**Re: Industrial Storm Water Inspection at Columbus Auto Shredding
(4GR00514*DG).
Franklin County**

Columbus Auto Shredding
Alum Creek Watershed

Figure 1: Process Water Recycling Impoundment

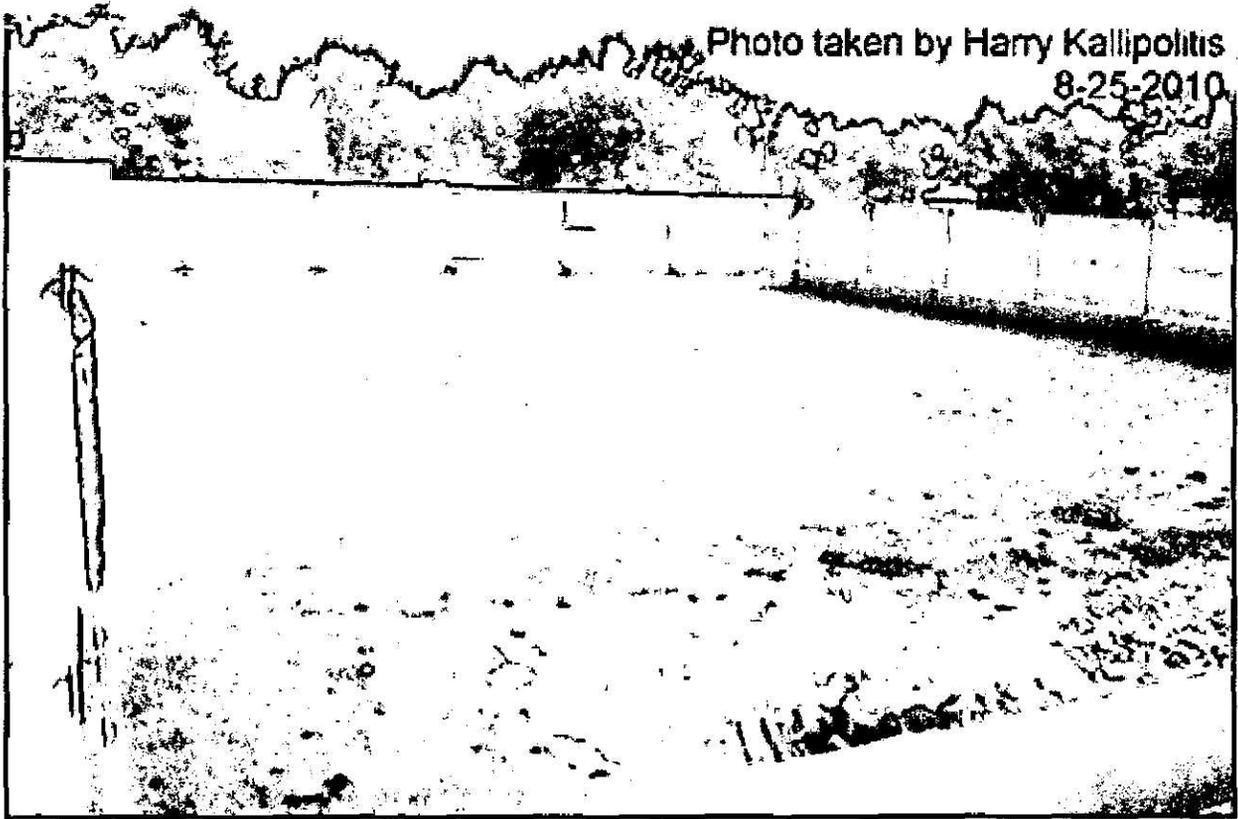
- During the inspection we evaluated the source of the odor complaint. Concurrent with past investigations by Ohio EPA, Division of Air Pollution, it was determined the odor originated from the processed waste water recycling impoundment (See Figure 1).
- As an interim measure, you diluted the processed water with fresh water to minimize odors. We discussed a permanent maintenance plan which included quarterly cleanout and removal of sludge in order to minimize odors. In the event this approach is not successful, you agreed to the installation of structural controls to minimize the potential of establishing an odor nuisance. The site will be evaluated on a quarterly basis to evaluate success.
